TECHNICAL QUERY
Hollandse Kust Noord

No. TQ :	CW-ROS-TQ-0006	Rev:	A

Originating Party	CrossWind					
Subject	Container lifting with slings					
Author	S. Bremner	TQ Aconex unique number: CWHKN-DEN-BPH-TQ-00005				
Interface TQ - from	Statron	TQ interface source Aconex unique number: STATRON-INN-BPH-TQ-00006				
Type	Query		X	Interface		X
	Deviation			Derogation (SHALL[PS])		
	Note: No deviations nor derogations which have an adverse effect on HSSE will be granted					
Workpackage	Baseload Power Hub					
Area(s) of application	Design & Eng.	x	Procurement		Construction	
	Commissioning		Operations		Other	
Issue date	12-02-2024		Urgent reply 5 days		Routine reply 10 days	x
Close-out date						
Closed-out by			TQ status:		Closed-out

4 Leg and 5 leg example images for reference

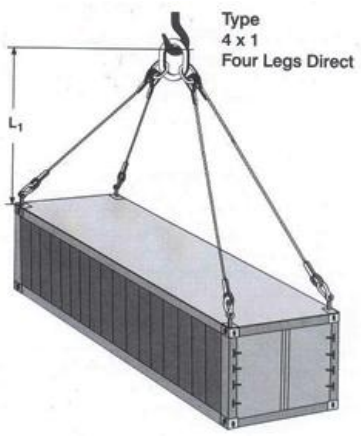
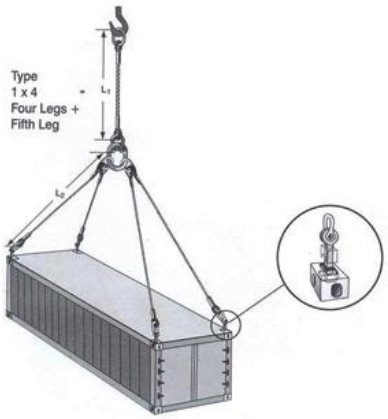
2) We provide a 4 leg sling, but if you have preference for 5 leg, please let us know shortly.

2) 5 leg sling is preferrable. Please provide specification of pins and thimbles before purchasing in order to verify the suitability with the used crane hook.

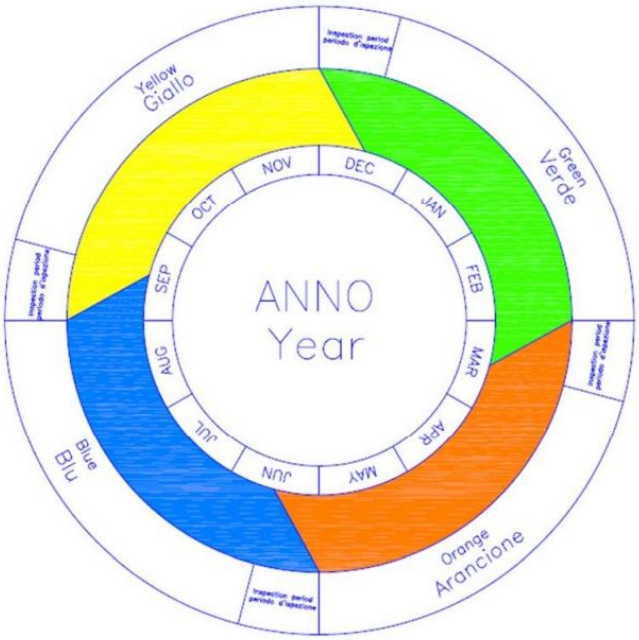
1) The container supplier will provide the sling and shackle numbers. If EPCI has special requirements or a specific numbering system for slings and shackles, please let us know shortly.

1) About certifications, for brand new lifting slings only CE Certification (valid until Aug 2025 as minimum) and manufacturer's manual are required. Slings and all lifting tools shall be certified to be used for more than one lifting (i.e. first the container will be lifted from truck to the yard and second from yard to BLPH) Please apply the correct color code on slings and shackles according to the following Color Code Wheel:
